**Total Maximum Daily Load for Fecal Coliform for the Lower Salinas River
Watershed,
Monterey County**

**March 18, 2010, Item 12
Staff Report Attachment 6**

PUBLIC COMMENTS AND STAFF RESPONSE

Figure 1. Alisal Creek Watershed monitoring data, and FMMP grazing land spatial extent.

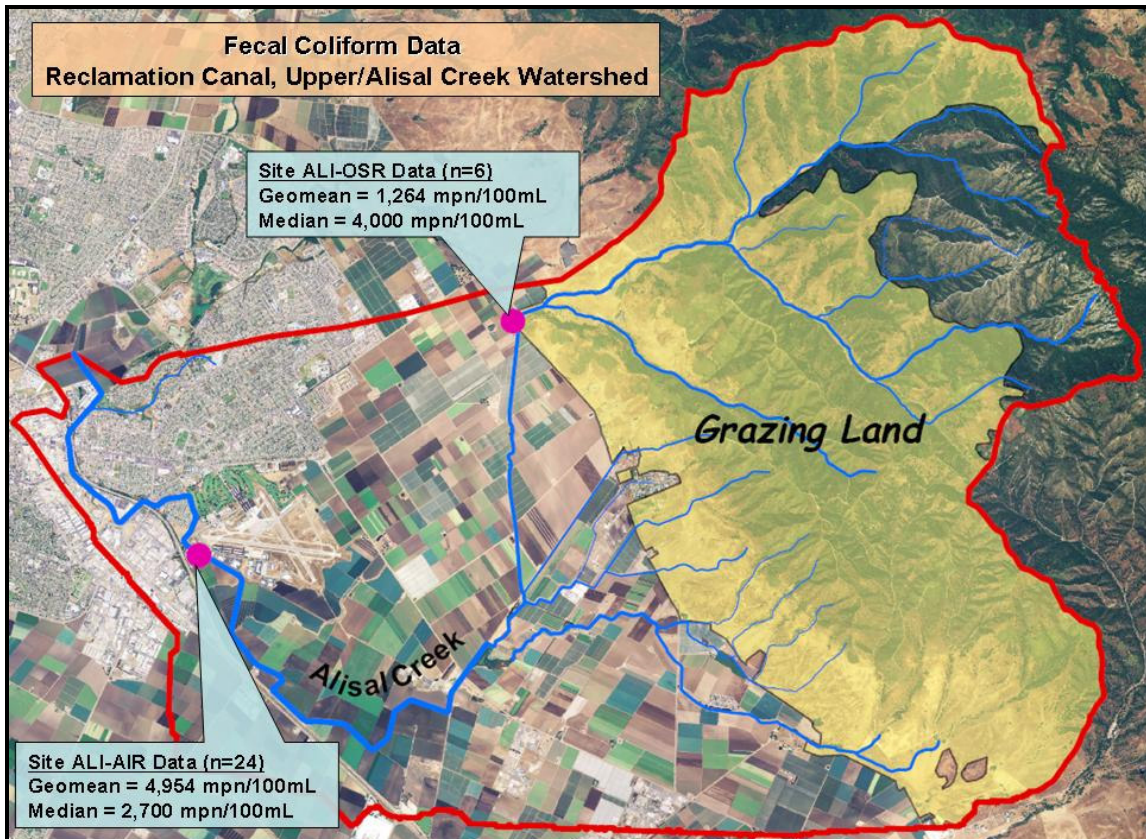
I represent Tom and Terry Bengard of Salinas who have asked me to comment on their behalf regarding the Draft TMDL Project Report for Fecal Coliform for the Lower Salinas River Watershed ("the Report").... The Bengards' ranch is located east of Old Stage Road in the area of the headwaters of Alisal Creek. The Report includes the Bengard property in a subarea (Sub-Area 3b) that takes in the rural and undeveloped headlands of Upper Alisal Creek along with a significant urban and suburban area of the City of Salinas. The blending of these two areas is reflected in the title of the sub-area: "Salinas Reclamation Canal, Upper/Alisal Creek" (p. 13, Table 2-3). We contend that inclusion of the undeveloped upper Alisal Creek area with the lower urban/suburban area along the reclamation Canal incorrectly and unfairly tilts the analysis of fecal coliform concentrations present east of Old Stage Road, including the Bengard ranch. Figure 3-1 (p. 23) and Table 3-1 (p. 25) appear to confirm that no test sites were located east of Old Stage Road in the upper areas of Alisal Creek.

With regard to the comment on monitoring data, please note that Water Board staff only collects stream data at locations with public access. Presumably, the upper reaches of the Alisal Creek watershed are on private property. However, there is monitoring data on Alisal Creek that captures grazing land drainage; please refer to Project Report Section 3.3 (Water Quality Data). Monitoring site ALI-OSR (Alisal Creek at Old Stage Road) reflects water quality data from drainages coming from the upper Alisal Creek catchments. As such, water quality from this site represents primarily grazing land runoff, with no urban, residential, or cropland inputs. Please refer to Figure 1.

Figure 1 shows the spatial extent of grazing land in the Alisal Creek watershed. The grazing land spatial data depicted in Figure 1 come from the Farmland Mapping and Monitoring Program (FMMP - California Dept. of Conservation, 2005). FMMP, in cooperation with the California Cattlemen's Association and others, developed digital mapping data depicting the location and extent of grazing lands. As such, this map illustrates that monitoring site ALI-OSR drains predominantly grazing lands. Monitoring data for fecal coliform is annotated on the map.

The fecal coliform concentrations in water quality samples for ALI-OSR significantly exceeded the REC-1 water quality screening objective (400 mpn/100mL); also, three of six samples (50%) from ALI-OSR also exceeded the much less stringent REC-2 (i.e., the non-water contact recreational use) water quality screening standard (4000 mpn/100mL). Note that the data from ALI-OSR contrasts with water quality data the Water Board has collected from undeveloped watersheds that are dominated by forest and native grass and that are devoid of any significant anthropomorphic or domestic animal operations. Indicator bacteria

concentration medians and ranges from undeveloped watersheds in the central coast region are typically more than an order of magnitude lower than those from ALI-OSR (for example, please refer to Figures 2 and 3 in this document).

Figure 2. Selected CCAMP Monitoring Sites, and Grazing Land and Forest Distribution (FMMP Dataset), Monterey County.

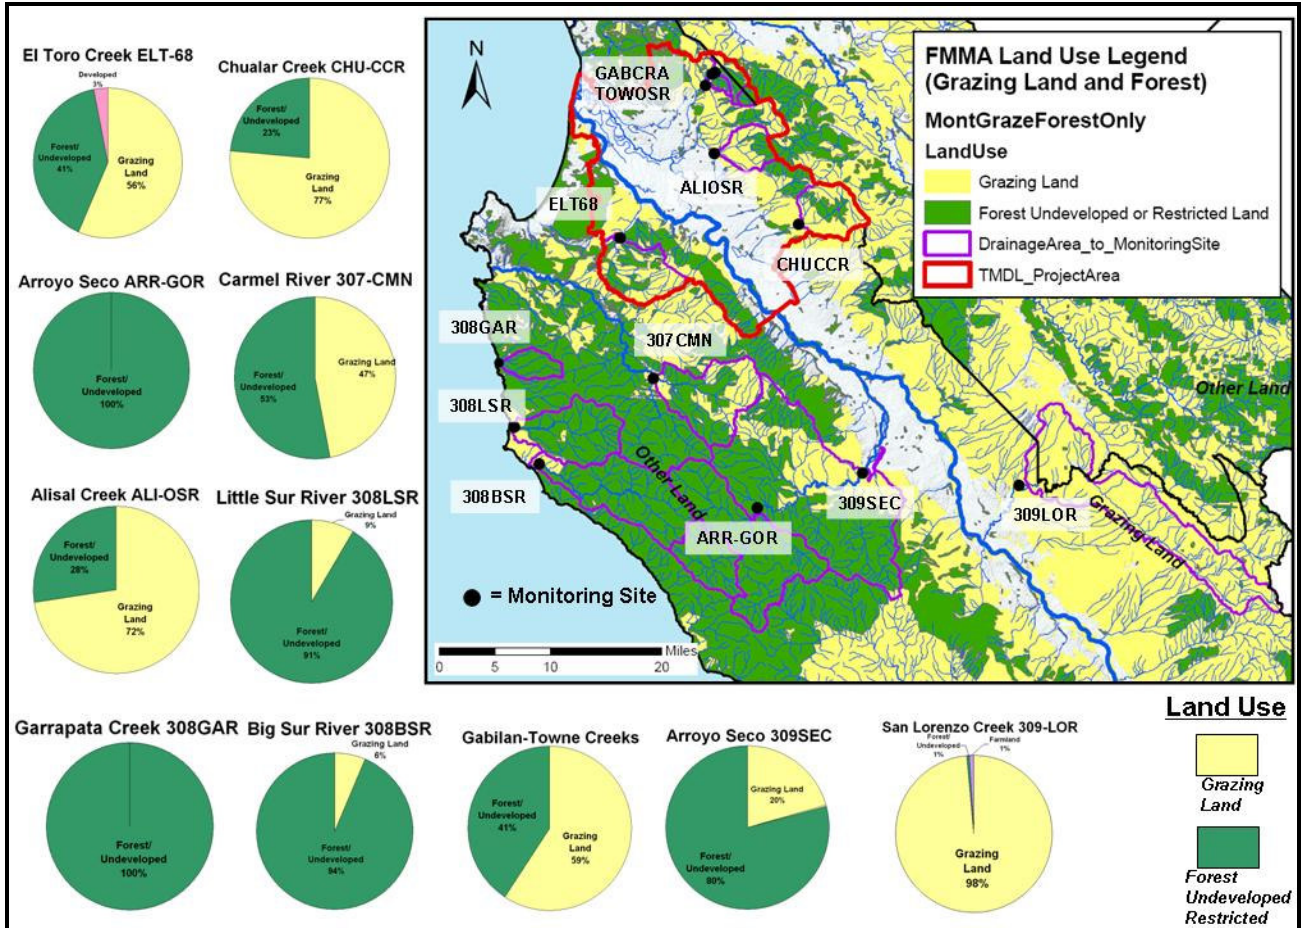
- *Comment: “Analyze and evaluate the data of Southern Monterey County (Arroyo Seco watershed). This is where land use is livestock/commercial and where RWQCB Staff there is NOT an exceedances of fecal coliform loads”*

However, based on continuing Stakeholder interest in the Arroyo Seco watershed, staff added additional analysis in the Project Report (see Section 4.3.3 of the Final Project Report), evaluating more broadly observed water quality data in Monterey County from monitoring sites draining exclusively grazing lands and/or forest-undeveloped lands. For ease of reference, parts of the relevant narrative from the Project Report are reproduced, below:

Consequently, staff evaluated water quality conditions from monitoring sites in Monterey County which drain only grazing lands and/or forest and undeveloped lands (i.e., monitoring sites where there are zero, or negligible urban, residential or cropland inputs). The results are presented in Figures 2 and 3.

Figure 2 illustrates the spatial extent of grazing land and forest/undeveloped lands in Monterey County, with selected CCAMP water quality monitoring points annotated on the map.

Bubble charts shown in Figure 2 depict the proportion of grazing lands versus forest/undeveloped lands in the catchments draining to each individual monitoring site. As the bubble charts show for this selected suite of monitoring
